# TOWNOFMILFORD,NH OFFICEOFCOMMUNITYDEVELOPMENT

Date: September 12, 2022

Subject: Gary Meissner and Barbara Prince-Meissner (owner) and Meridian Land Services, Inc. (applicant) – Review for acceptance and consideration of a major subdivision to subdivide Tax Map 41, Lot 38-1 creating four total lots. The parcel is located at 325 Osgood Road, just west of the intersection of Burns Road and Osgood Road, in the Residence 'R' Zoning District.

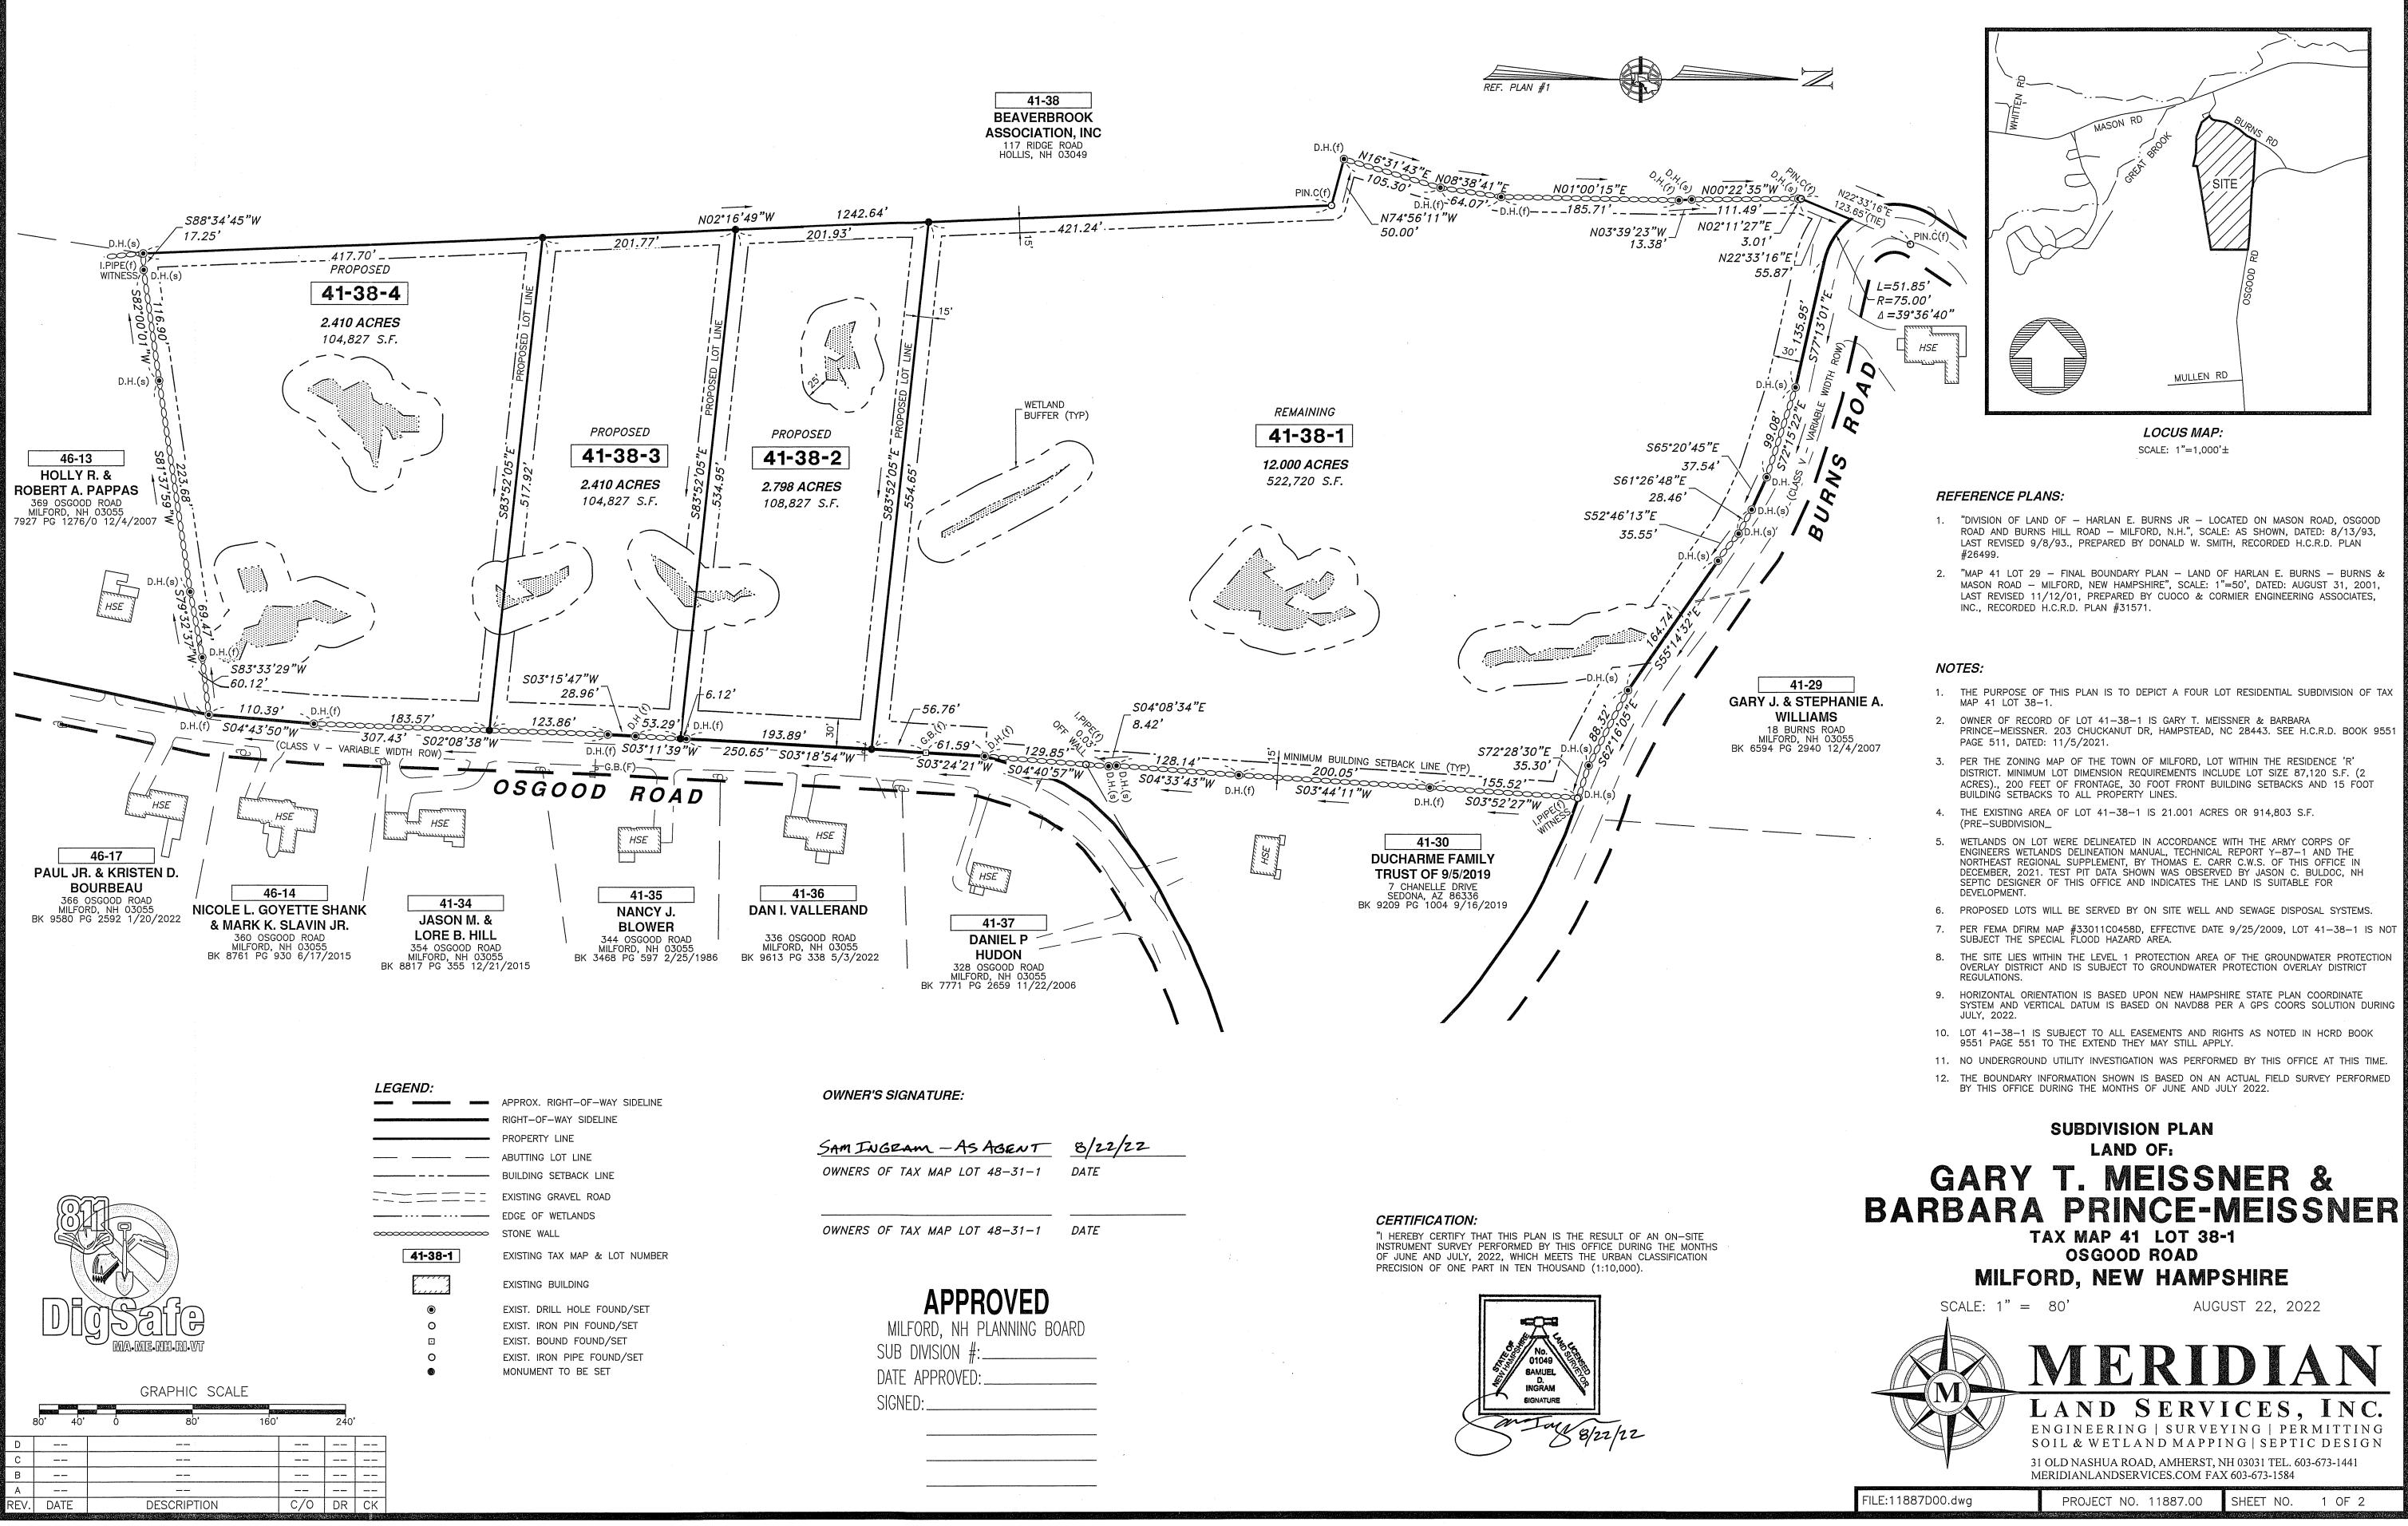
- 1. General Question. Please update Notes by organizing the lots and dimensional requirements into a chart.
- 2. General Comment. Curb cut approvals from the Town will be required for Map 41-38-1, 41-38-2. 41-38-3 and 41-38-4 from Osgood Road.

- 3. General Comment. Please confirm that the proposed driveways meet all local requirements related to site distance.
- 4. General Comment. Please provide an owner of record and mailing address for each of the newly created lots.

- 5. Please add a note stating: "no stonewalls or trees of 15" circumference or larger are to be removed within the Osgood Road Right-of-Way without a Planning Board Scenic Road public hearing. Where possible, all existing stonewalls should be retained."

- 6. Please add a note stating a stormwater management & erosion control plan will be required for any land disturbance greater than 5,000 SF.
- 7. Subdivision Plan. A note shall be added to the plan stating that prior to the signing of the plan, all monumentation shall be set and noted on the plan or a security be provided to the Town to cover the cost of monumentation. Further, please be sure to include all bounds for each of the affected lots. See Milford Development Regulations, Section 6.021 Bounds for more information and specifications.

- 8. Subdivision Plan A note shall be added to the plan stating State of NH site specific permit numbers.
- 9. A note shall be added to the plan stating that all private residences are exempt from the provisions of the Groundwater Ordinance provided no portion of the residence is part of a home business that violates the standards or conditions set forth in sections 6.01.2 and 6.01.3 of this Ordinance;

- 10. A note shall be added to the plan stating that in accordance with the Groundwater Ordinance, storage of heating fuels for on-site use or fuels for emergency electric generation, shall be in indoor storage tanks on an impervious concrete floor or have corrosion control, leak detection, and secondary containment in place.
